KC ID #340 Question

Chapter 7 Direct strength assessment

Section 2 Global Strength FE analysis of cargo hold structures.

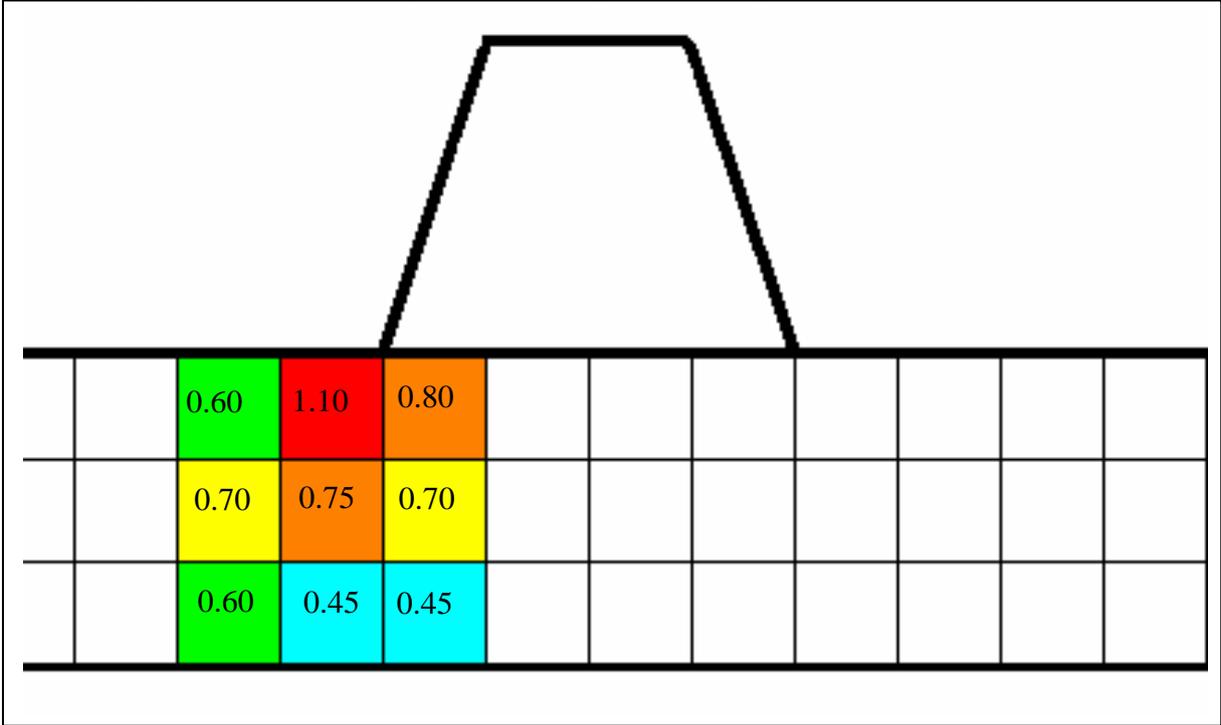
Q3: A typical connection of a longitudinal girder to the lower stool is shown in the figure below. A typical utilization for yield in a heavy ballast cargo hold is indicated $\sigma_{eq}/\sigma_{accetp.}[3.2.3]$.

Assuming all 3 elements are equally sized over the height of the double bottom as indicated on the figure. What is the correct application of [3.2.3]?:

- a. Each individual element over the height has to be within the requirement of [3.2.3]. That is, the red element has to be reinforced until the utilization is < 1. ?
or
- b. The results may be averaged over a typical stiffener spacing, SxS, in the double bottom as indicated with grey in the below figure. The averaged utilization should be <1?

Assuming the 3 elements are slightly different in size. What is the correct application of [3.2.2]?:

- c. Each individual element over the height has to be within the requirement of [3.2.3]. That is, the red element has to be reinforced until utilization is < 1.?
or
- d. The results may be averaged over a typical stiffener spacing, SxS, in the double bottom. The averaged utilization should be <1?
or
- e. The results may be averaged based on an element size = $H_{dblBottom}/3$?
